DART AEROSPACE LTD	Work Order:	97863
Description: Crosstube Assembly (205/212/412 High Fwd)	Part Number:	D212-664-141
Inspection Dwg: D212-664-141 Rev: D		Page 1 of 2

DRAWING NO. D212-664-141	TITLE XTUBE ASSY (205/212/412 HI FWD)	REV. D	DART AEROSPACE LTD ENGINEERING ORDER		D.E.O. NO. D212-664-141-D-1	SHEET NO. SHEET 1 OF 2	SCALE NTS
DRAWN	CHECKED	AP	MFG. APPR.	ER	APPROVED	MA	DE APPR.
DATE 11.04.07	DATE 11.04.11		DATE 11.04.12		DATE 11/04/12		DATE 11.04.12

DRAWING NO. D212-664-141	TITLE CROSSTUBE ASS'Y (205 HI FWD)	REV. D	DART AEROSPACE LTD ENGINEERING ORDER		D.E.O. NO. D212-664-141-D-2	SHEET NO. SHEET 1 OF 1	SCALE NTS
DRAWN <i>UP</i>	CHECKED <i>AS</i>	MFG. APPR. <i>AS</i>	APPROVED <i>MD</i>	DE APPR. <i>HH</i>			
DATE 11.07.15	DATE 11.07.20	DATE 11.07.21	DATE 11/07/21	DATE 11.07.21

DRAWING NO. D212-664-141	TITLE XTUBE ASSY (205/212/412 HI FWD)	REV. D	DART AEROSPACE LTD ENGINEERING ORDER		D.E.O. NO. D212-664-141-D-3	SHEET NO. SHEET 1 OF 1	SCALE NTS
DRAWN AJS	CHECKED JP	MFG. APPR. 140	APPROVED 140		DE APPR. 140		
DATE 12.06.28	DATE 12.07.05	DATE 12.07.05	DATE 12.07.05		DATE 12.07.05

**D212-664-141/-141B
ASSEMBLY DETAIL**

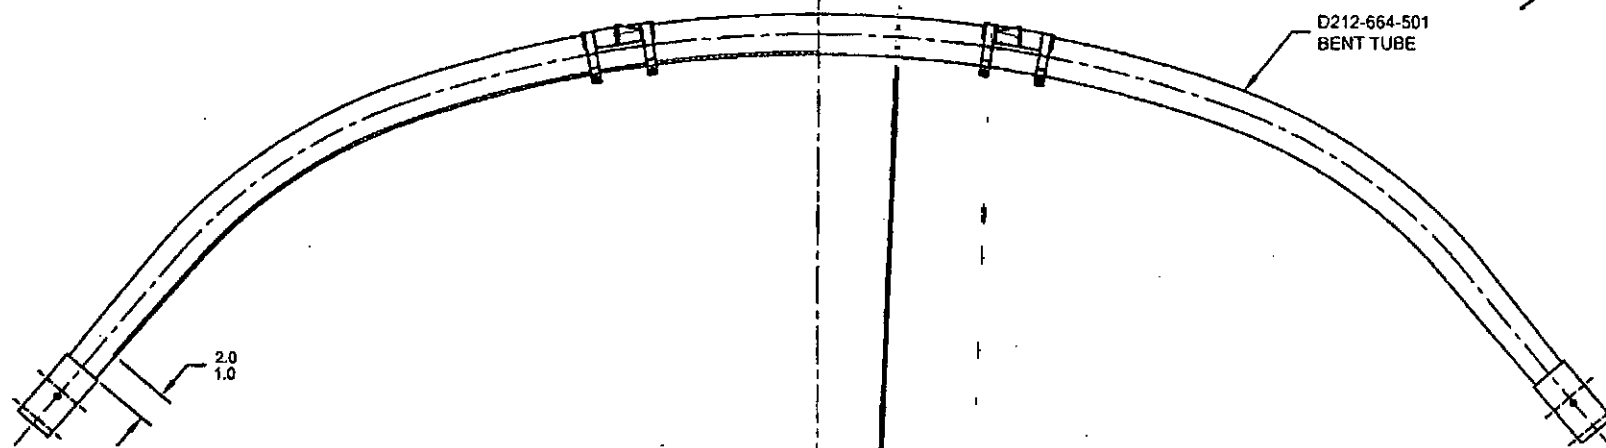
PURPOSE:

ADD AN INSPECTION WINDOW TO UNDERSIDE OF CROSSTUBE.

NOTES 2 OF SHEET 1 IS AMENDED AS FOLLOWS:

- 2) FINISH: CHEMICAL CONVERSION COAT PER DART QSI 005 4.1
PRIME INSIDE AND OUTSIDE PER DART QSI 005 4.2
MASK UNDERSIDE OF CROSSTUBE AS SHOWN (HATCHED AREA) AND
PAINT OUTSIDE PER DART QSI 005 4.2
REMOVE MASKING AND APPLY CLEAR COAT

MASK AREA PRIOR TO PAINTING,
REMOVE MASKING AFTER PAINT
AND APPLY CLEAR COAT
